Paper #GMD-2024-87 | Model experiment description paper: 'Design, evaluation and future projections of the NARClIM2.0 CORDEX-CMIP6 Australasia regional climate ensemble'

Table 1. Anonymous Referee 1 (RC1) Comments

Table 2. Anonymous Referee 2 (RC2) Comments

Table 3. Anonymous Referee 3 (RC3) Comments

Figure 1 (New, see comment #9 above). Future projections of mean maximum temperature for the ensemble means of CMIP5 GCMs forcing NARClIM 1.5 and CMIP6 GCMs forcing NARClIM 2.0

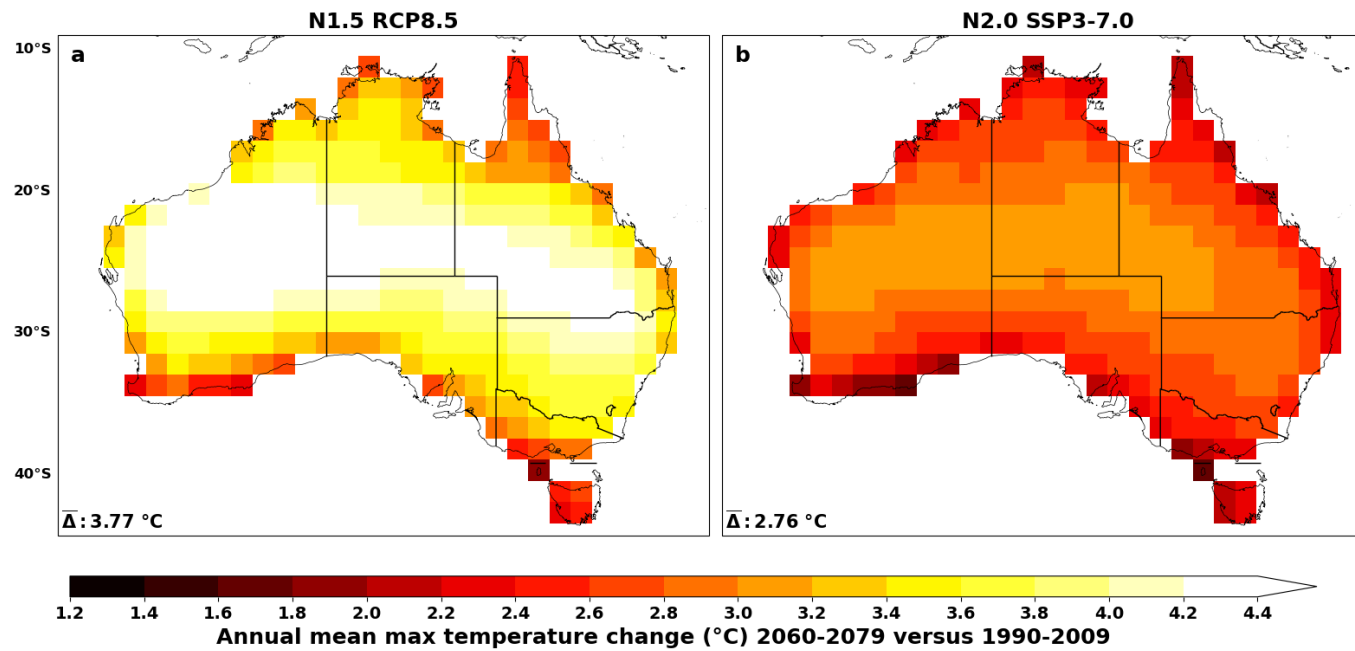
the biases/RMSEs are in different order of magnitude. The authors may consider employing the Model Climate Performance Index (Gleckler et al., 2008) or multivariable integrated skill score (Zhang et al., 2021) for a comprehensive assessment in terms of the model performance in simulating multiple variables.	were then summed to determine the overall ranking for each RCM. Thank you for suggesting these references; in particular, in future studies we will try the approach of Zhang et al., (2021).	we ranked the RCMs individually based on their bias, RMSE, and PSS for maximum temperature, minimum temperature, and precipitation. Each variable was ranked separately for each metric. The ranks were then summed to determine the overall ranking for each RCM."
8	L699: Please replace "CMPI6" with "CMIP6".	Thank you for pointing that out – corrected.	"CMPI6" corrected to "CMIP6".
9	L707-712: Could you explain why projected changes in TAS exhibit distinct spatial patterns between NARCIIM 2.0 and NARCIIM 1.5/1.0?	Thanks for this comment. In this work, we looked at future projections of mean maximum temperature (TASMAX) rather than mean temperature (TAS). Given your comment, we compared differences in the spatial patterns of projected changes in both TAS and TASMAX between CMIP6 and CMIP5 GCMs (please see Figure 1 below this table, p.10; shown here, but not added to revised manuscript). Both GCM generations show broadly similar spatial patterns of change (at least qualitatively). However, there are clear differences in magnitude, e.g. whilst both CMIP5-6 show stronger warming changes across an east-west band of central Australia, the magnitude of change is larger for CMIP5, probably in large part to the differences in GHG assumptions. Additionally, GCM skill in simulating observed TASMAX is fairly similar for both GCM generations (see Supporting Information Figure S7), noting though that the spatial patterns of bias are somewhat different (e.g. the CMIP6 ensemble mean is more cold biased over northern Australia than CMIP5; conversely the CMIP5 GCM ensemble mean is more cold biased over southern and eastern Australia).	The manuscript had stated the need for further work in this space, noting our comments here in the column left. Lines 928-931: "Other differences in the projections between NARCIIM generations require further investigation in order to explain, such as NARCIIM 1.5's latitudinal warming gradient for maximum temperature that contrasts with NARCIIM 2.0's band of faster warming over central Australia relative to northern and southern regions."

<p>This topic requires an additional in-depth investigation to understand and explain. For example, TMAX is usually driven at the larger scale by changes in MSLP, e.g. the sub-tropical ridge and its intensification, this in turn probably affects changes in precip. and surface energy balance, so we would need to examine changes in potentially: MSLP, precip., soil moisture, sensible, latent heat fluxes etc. Our aim with this current work is to explain key model design processes and the basic performance characteristics of the NARClIM models, i.e. to lay a foundation for future work in this space, hence an investigation like the above, whilst very interesting, is more within the scope of a new study. There might be several factors that underlie the different/distinct spatial patterns in projected temperature changes for NARClIM 2.0 and NARClIM 1.x. For instance, changes in model spatial resolution are one possible candidate, given that the resolution of CMIP6 GCMs is higher than CMIP5 GCMs, and the same applies to NARClIM 2.0 RCMs versus its predecessors. However, we expect that there will be other factors that explain the observed differences in NARClIM RCM behaviour.</p>

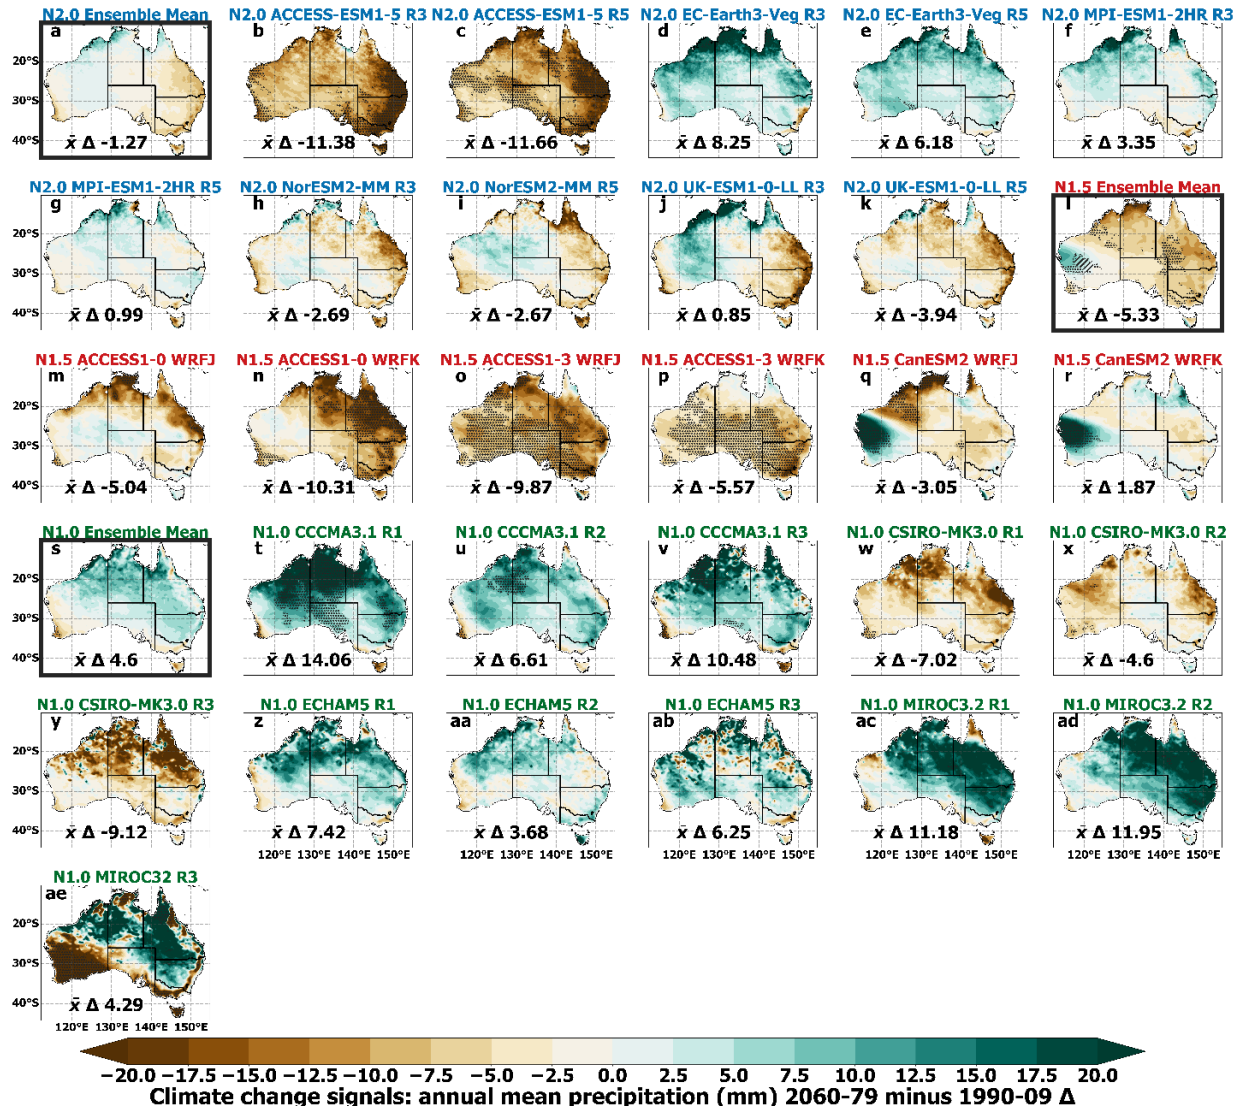
10	<p>Fig.15: The quality of this figure appears low. Why do the stippling areas form very regular circles in the many subpanels, e.g., b, c, e, n, p, t, u, v? Consider presenting these figures as supplementary material and summarizing the statistics using a Taylor diagram.</p>	<p>We agree that the quality of the original Figure 15 was insufficient: this figure is now revised, e.g. with DPI increased from 300 to 600, stippling size increased, panel title font size increased, etc., – please see revised figure below this table.</p>	<p>Figure 15 revised as described in column left and included in the revised manuscript (please also see revised figure below this table, p. 11).</p>
11	<p>L804-816: These discussions are somewhat tangential to the study's main focus and could be shortened or omitted. Instead, further</p>	<p>This study focuses on summarizing the improvements in the NARClIM2.0 design, including the incorporation of the Noah-MP land</p>	<p>As suggested, the section of text in question has been substantially shortened in the revised manuscript. Additionally,</p>

Figure 15 revised figure and caption: “**Figure 15.** Climate change projections (1990-2009 versus 2060-2079) for annual mean precipitation for NARClIm ensemble mean climate change signals (a,i,s) and for individual ensemble members for each generation of NARClIm simulation (NARClIm 2.0 under SSP3-7.0, NARClIm 1.5 under RCP8.5 and NARClIm 1.0 under SRES A2). Significance stippling as per Figure 9.”

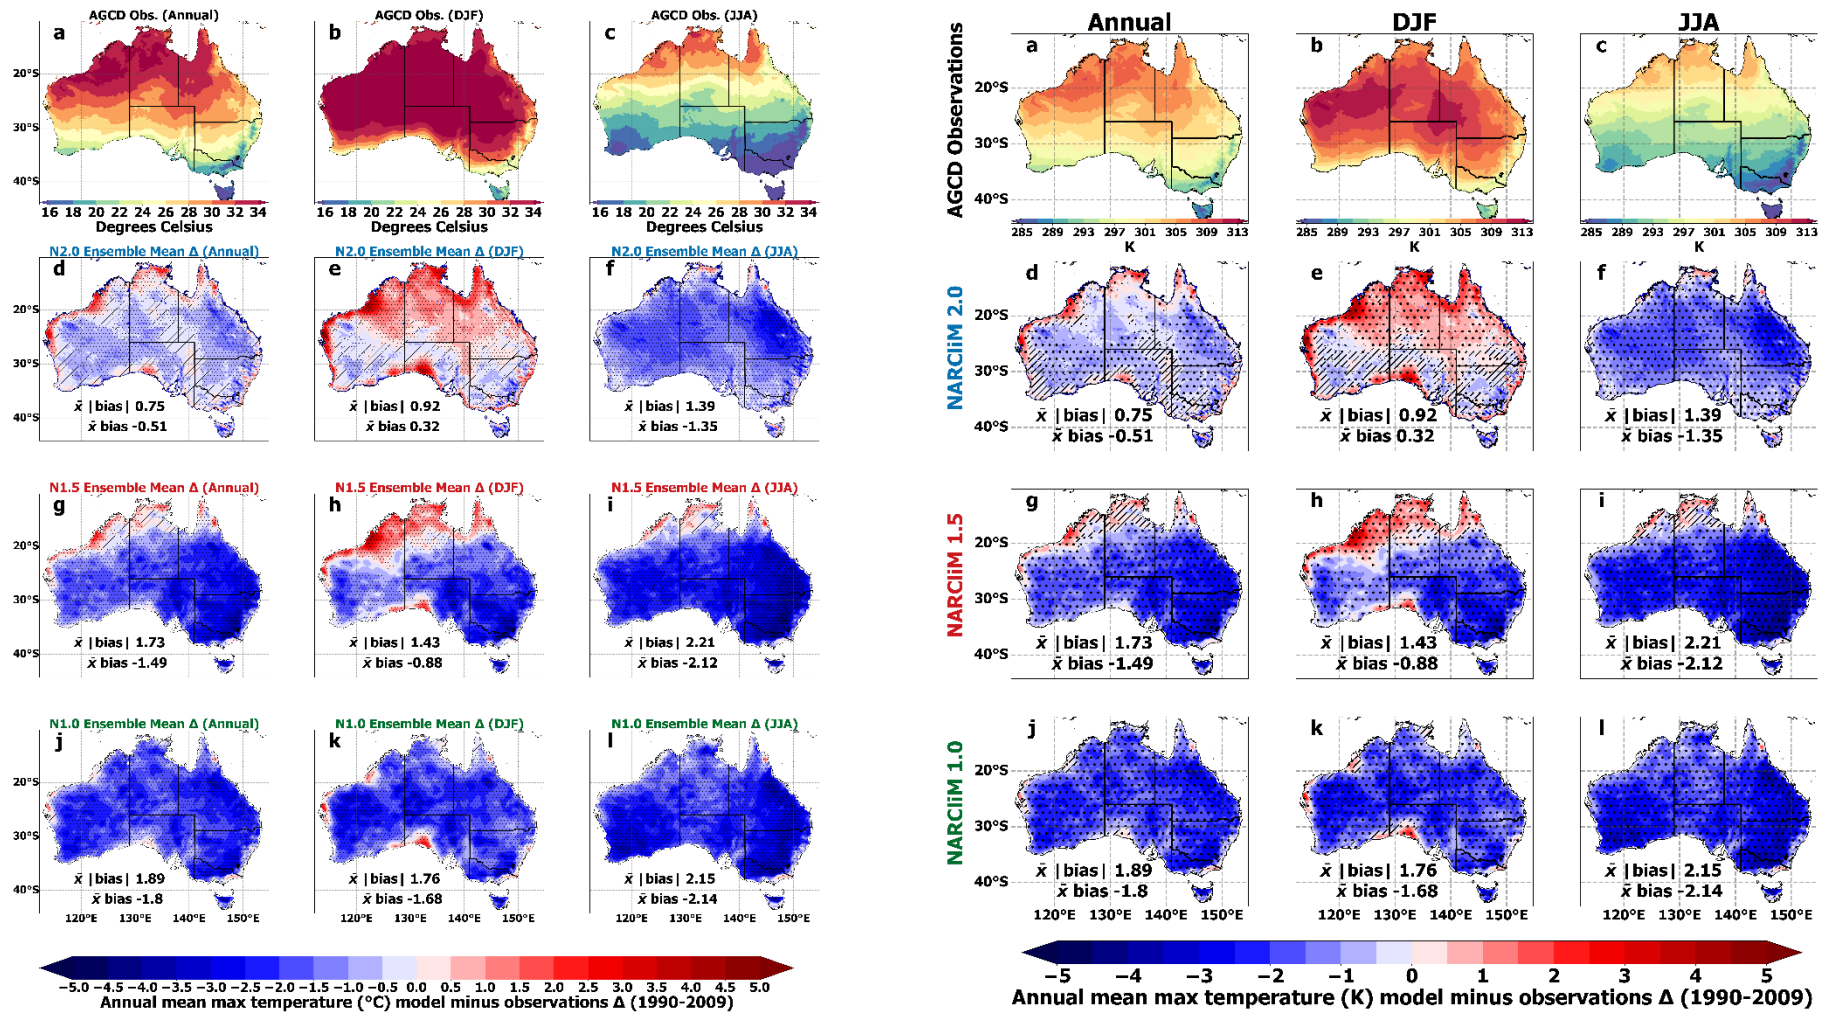
5	Obviously a large effort has gone into producing the convection-permitting resolution model output. However, the improvements are mostly seen in temperature and not in precipitation. Perhaps this is because the focus here is on evaluating mean precipitation and not extremes? Can the authors comment further on this? Referring and discussing other international literature here would be useful also.	In this study, the scope was to focus on an initial ‘first-order’ evaluation of mean precipitation rather than extremes of precipitation. However, clearly much valuable research can now be undertaken into evaluating the skill of NARClIM2.0 in simulating extreme precipitation, subdaily precipitation, etc, using NARClIM 2.0 20 km and 4 km data, especially since these data are now publicly available. A great avenue for further research is to assess the potential value-add in simulating extreme and subdaily precipitation at convection permitting scale versus the convection-parameterised 20 km data. This is now stated in the revised manuscript.	<p>Text added to the revised manuscript as per column left / shown below (lines 889-897).</p> <p>“More generally, the scope of the present study was to focus on an initial “first-order” evaluation of mean precipitation rather than extremes of precipitation. However, clearly valuable research can now be undertaken into evaluating the skill of NARClIM 2.0 in simulating extreme precipitation, subdaily precipitation, etc, using NARClIM 2.0 20 km and 4 km data, noting these data are now publicly available. A good avenue for further research is to assess the potential added value in simulating extreme and subdaily precipitation at convection permitting scale versus the convection-parameterised 20 km data.</p>

<p>In term of previous works: multiple studies have confirmed that convection-permitting resolution model can improve simulating daily and sub-daily rainfall extremes (Xie et al., 2024; Cannon and Innocenti, 2019; Kendon et al., 2017). In future work, we will also assess added value of convection-permitting resolution model in simulating precipitation related extremes.</p> <p>Xie, K., Li, L., Chen, H., Mayer, S., Dobler, A., Xu, C.-Y., and Gokturk, O. M.: Enhanced Evaluation of Sub-daily and Daily Extreme Precipitation in Norway from Convection-Permitting Models at Regional and Local Scales, Hydrol. Earth Syst. Sci. Discuss. [preprint], https://doi.org/10.5194/hess-2024-68, in review, 2024.</p> <p>Cannon, A. J. and Innocenti, S.: Projected intensification of sub-daily and daily rainfall extremes in convection-permitting climate model simulations over North America: implications for future intensity–duration–frequency curves, Nat. Hazards Earth Syst. Sci., 19, 421–440, https://doi.org/10.5194/nhess-19-421-2019, 2019.</p> <p>Kendon, E. J., and Coauthors, 2017: Do Convection-Permitting Regional Climate Models Improve Projections of Future Precipitation Change?. Bull. Amer. Meteor. Soc., 98, 79–93,</p>	<p>Several previous studies have confirmed that convection-permitting resolution models can improve the simulation of daily and sub-daily rainfall extremes (Xie et al., 2024; Cannon and Innocenti, 2019; Kendon et al., 2017).”</p>

Reviewer 2, Comments #6 and #11. Left: original **Figure 9** from initial submission; Right: revised **Figure 9** using revised statistical significance method (please see #6) and revised plot layout/headers and labelling and increased DPI (please see #11)

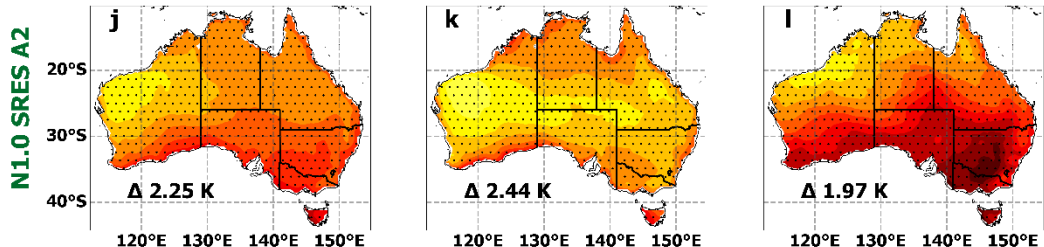
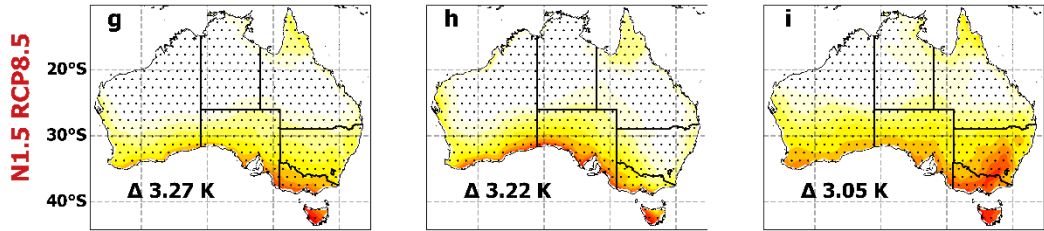
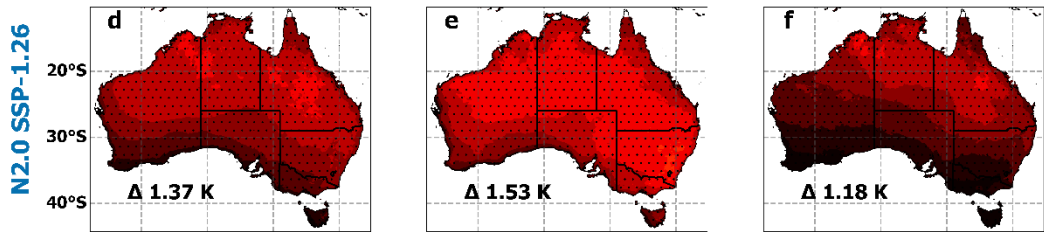
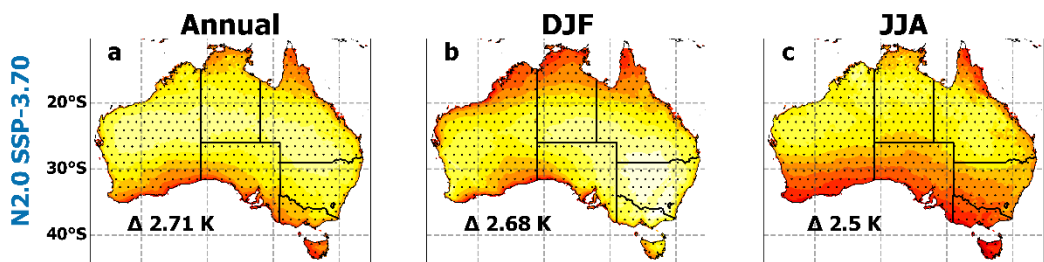
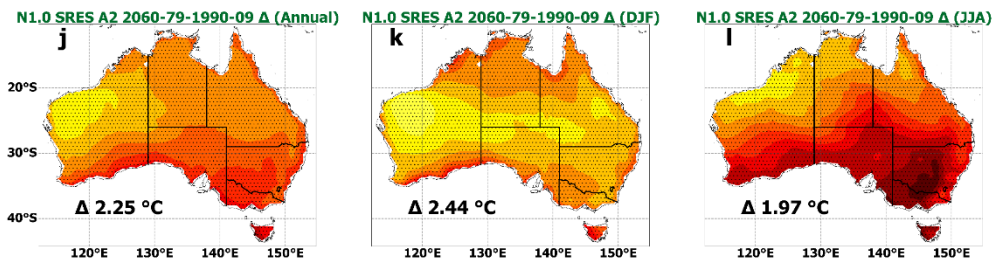
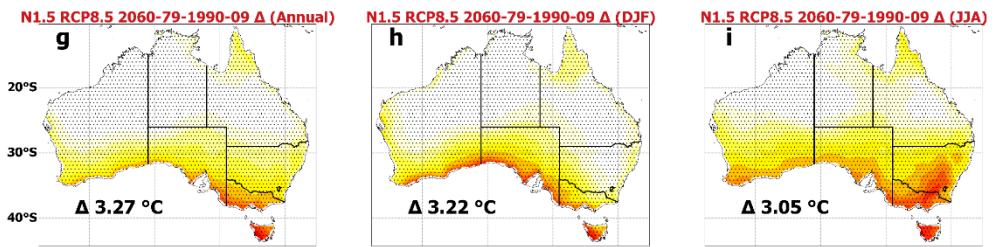
https://doi.org/10.1175/BAMS-D-15-0004.1 .	
6	<p>On statistical significance. My personal view is that statistical significance is generally misunderstood and misinterpreted in climate science. However, I do think using significance in terms of model agreement is much more defensible (as you have done on top of this). If statistical significance is used, the authors also need to account for multiple testing (e.g. via the false discovery rate), which does not appear to be done:</p> <p>https://journals.ametsoc.org/view/journals/bams/97/12/bams-d-15-00267.1.xml?tab_body=abstract-display</p>	<p>Thank you for your suggestion and the reference you have posted is interesting and something we have applied in the revised version of this manuscript and will continue to apply going forwards.</p> <p>The ensemble mean based plots (Figures 9-14 and panels a, l and s in Figure 15) are the only plots where we combine multiple collections of null hypotheses. For these Figures 9-14 (and panels a, l, and s in figure 15) we have included revised plots with a corrected criterion using Walker’s test using Eq.2 from the reference you provided. We applied Walker’s test as this is stricter than FDR and easier to implement at this stage. Using this revised method, dependent on the NARClIM ensemble in question, alpha values change from 0.05 to $\alpha = 0.0051162$ (for example). We found no major visible changes to the significance results / significance stippling of our plots for temperature biases and future projections, as can be observed in the comparison of original versus revised figure versions shown below this table. Here, the results are similar between the original version and the revised version implementing your suggestion, e.g. temperature climate change signals show widespread significant future changes.</p>	<p>Reviewer’s suggestion implemented and Figures 9-15 revised in the revised manuscript as described in column left (please see also example figures below this table, pp. 21-23). Evaluation methods in the revised main text now states the additional text below (lines 212-213); results/figures in question revised throughout as indicated in column left:</p> <p>“Significance thresholds were adjusted to account for multiple testing using Walker’s test (Eq.2 in Wilks, 2016)”.</p>

9	Figure 4, for precip, are the units mm/day?	Thanks for asking this question, yes, the units are mm/day – figure caption revised accordingly.	Figure caption revised for units.
10	Figure 9 (and others), I found it difficult to see the stippling/hatching. The resolution of the file was low (not sure if this was an issue with the pdf	We agree that Figure 15 is difficult to read, e.g. the original version was 300 DPI; we have now increased the DPI to 600, among other	Figure 15 revised as suggested (please see example below this table, p.24).

<p>Before implementing the reviewer’s suggestion, the original results for precipitation climate change signals tended to be non-significant over most regions for most models. Having implemented the reviewer’s suggestion, there are fewer locations showing statistically significant future changes for mean precipitation (see comparison figures below this table, pp. 21-23).</p>	
7	<p>In Figure 15, is there an understanding of why the projections for ACCESS-ESM1-5 projections are so dry? Presumably this is in the GCM also? Do we know why that is from the physical perspective?</p>	<p>ACCESS-ESM1-5 driven RCM simulations project very dry futures for Australia, which is mostly inherited from the GCM. There are 40 realisations for ACCESS-ESM1-5, but only realisation 6 provides sub-daily outputs that can be used in dynamical downscaling using WRF. This realisation simulates a particularly dry projection over Australia, especially for eastern Australia, making it a useful “stress test” case. It also shows that internal variability within the GCM is a factor in producing this dry projection. Please see more details in: https://research.csiro.au/access/model-ensembles-to-understand-climate-variability-and-change/</p> <p>In terms of GCM skill versus observations, globally, this GCM is dry biased over a few regions owing to a location bias with the Inter-tropical Convergence Zone (ITCZ), e.g. see Ziehn et al. (2020): CSIRO PUBLISHING Journal of Southern Hemisphere Earth Systems Science</p>	<p>Text shown below added to the revised manuscript (lines 941-950).</p> <p>“Some NARClIM 2.0 RCMs produce very similar precipitation projections for certain GCM-RCM combinations. Notably, ACCESS-ESM-1-5-R3 and R5 under SSP3-7.0 both produce widespread dry projections that are substantially drier than other NARClIM 2.0 models. This GCM projects very dry futures across Australia (Di Virgilio et al., 2022), so this result in the R3 and R5 RCMs could be largely inherited from the driving data. There are 40 realisations for ACCESS-ESM1-5, but only realisation 6 provides sub-daily outputs that can be used in dynamical downscaling using WRF. This realisation simulates a particularly dry projection over Australia, especially for eastern Australia, making it a useful "stress test" case. In terms of GCM skill versus observations, globally, this GCM is dry biased over a few regions owing to a location bias with the Inter-tropical Convergence Zone (Rashid et al., 2022; Ziehn et al., 2020).”</p>
